**UNITED STATES
NUCLEAR REGULATORY COMMISSION
REGION IV
611 RYAN PLAZA DRIVE, SUITE 400
ARLINGTON, TEXAS 76011-8064**

**SUBJECT: NRC AUGMENTED INSPECTION TEAM (AIT) REPORT 50-483/02-07 AND
PRELIMINARY WHITE FINDING - CALLAWAY PLANT**

Callaway Plant NRC Inspection Report 50-483/02-07

IR 05000483-02-07; on 01/28-02/27/2002; Union Electric Co; Callaway Plant. Augmented Inspection Report; Problem Identification and Resolution, Modifications. One preliminary White finding.

Figure 1
Auxiliary Feedwater System
Simplified Diagram

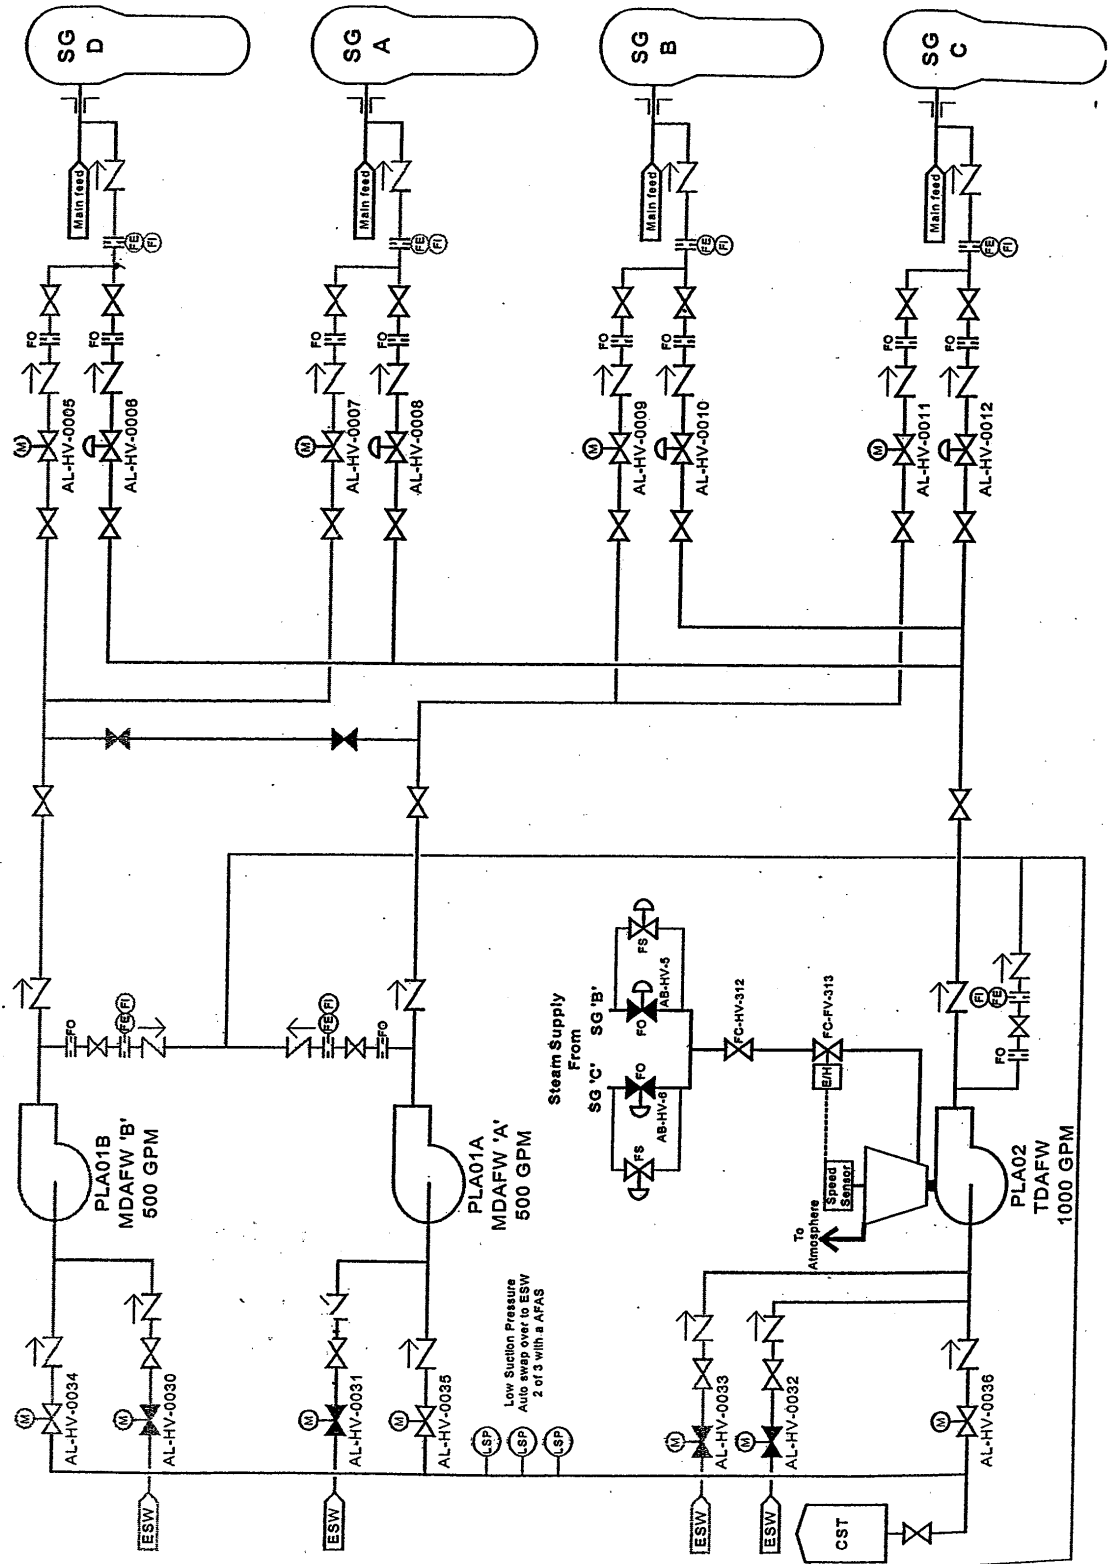
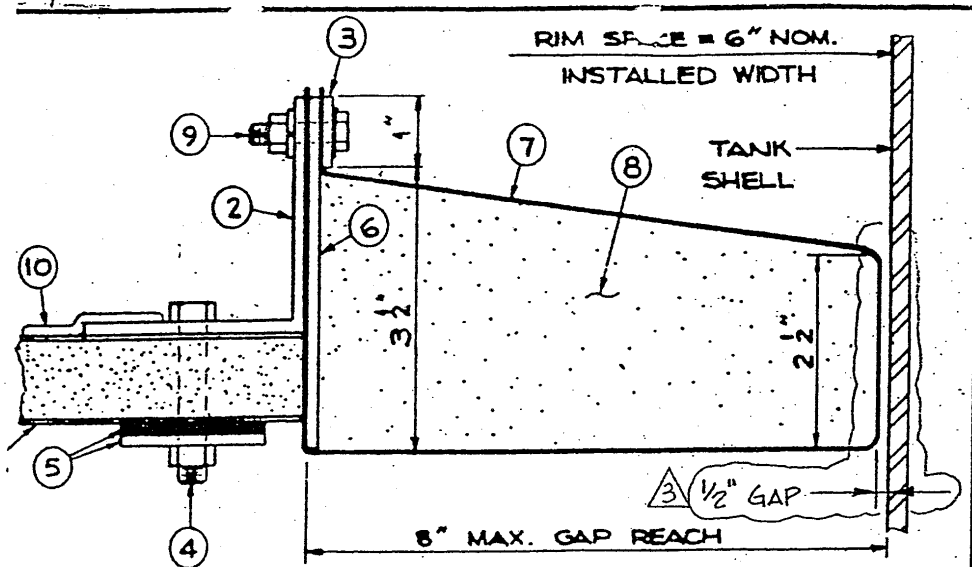
The auxiliary feedwater (AFW) system has 2 motor-driven pumps (A and B) and 1 turbine-driven pump. The pumps were normally aligned through a common suction line to the non-safety related condensate storage tank (CST). The essential service water system was credited as the safety-related source of make-up water to the steam generators. The AFW pump suction automatically switched from the CST to the essential service water system following a low level condition in the CST (See Figure 1).

Condensate Storage Tank
Diaphragm Seal

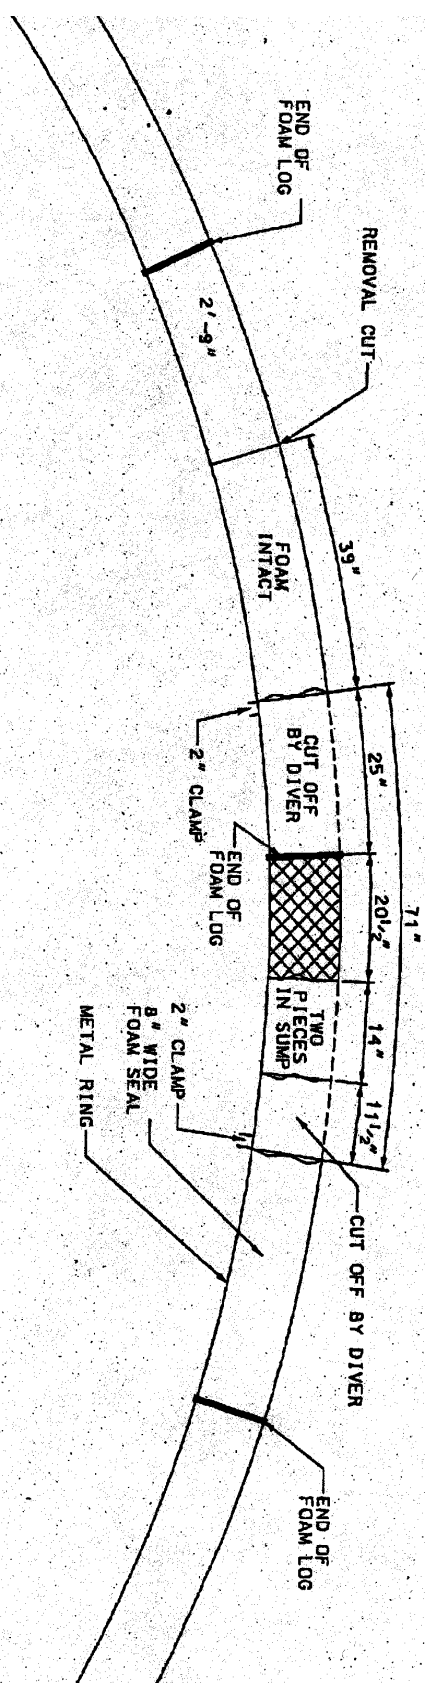
The CST diaphragm was a rigid structure that floated on the surface of the water to minimize the oxygen content of the water in the CST. The diaphragm was approximately 43 feet in diameter and constructed of rigid closed cell foam laminated with fiberglass and polyester resin. A seal was attached to the diaphragm and located between the outer periphery and the inner surface of the CST. The seal was constructed of soft pliable polyurethane foam covered with a Teflon-coated fiberglass fabric. The fabric reduced the frictional forces between the seal and the inside wall of the CST when the water level fluctuated (See Figure 2).

On January 26 and 27, 2002, the licensee found foreign material in the CST. The foreign material mainly consisted of pieces from the diaphragm seal assembly. The seal materials consisted of a Teflon-coated fiberglass fabric, flexible polyurethane foam, caulking material, and a piece of fiberglass (See Figure 2).

Condensate Storage Tank Configuration

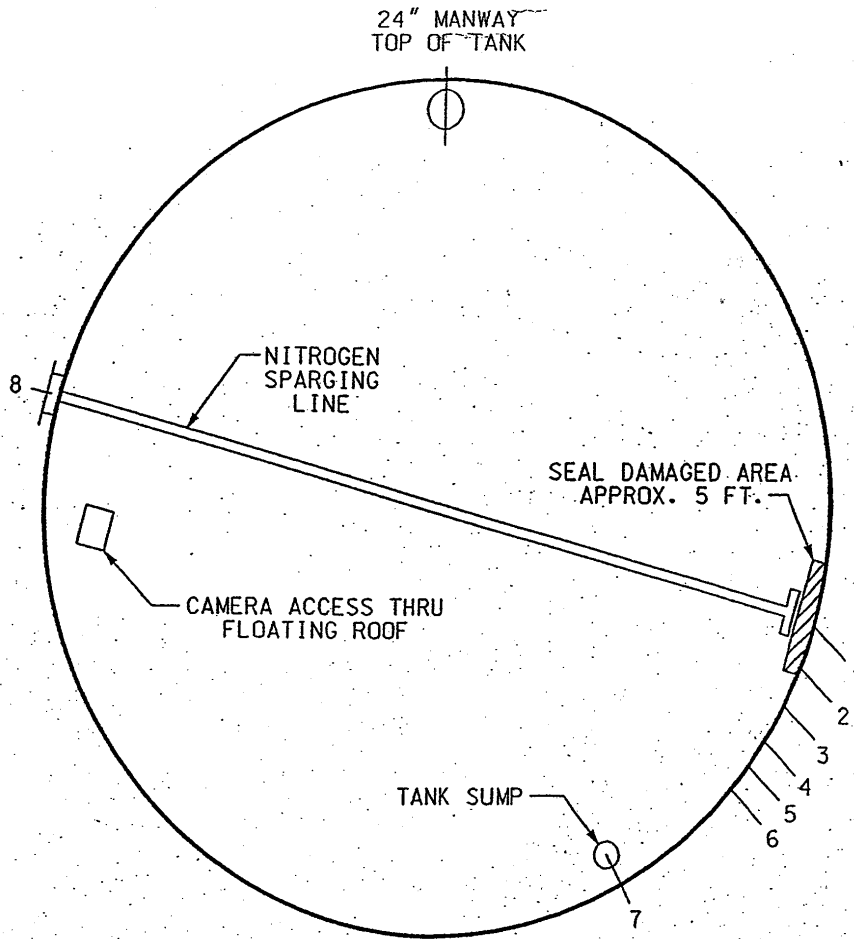
The team determined that the degradation of the seal was limited to a 71-inch circumferential section of the diaphragm. The degraded portion of the diaphragm seal was located above the single suction source of the AFW system (See Figure 4). The following table provides a listing of the missing foam portions of the seal.
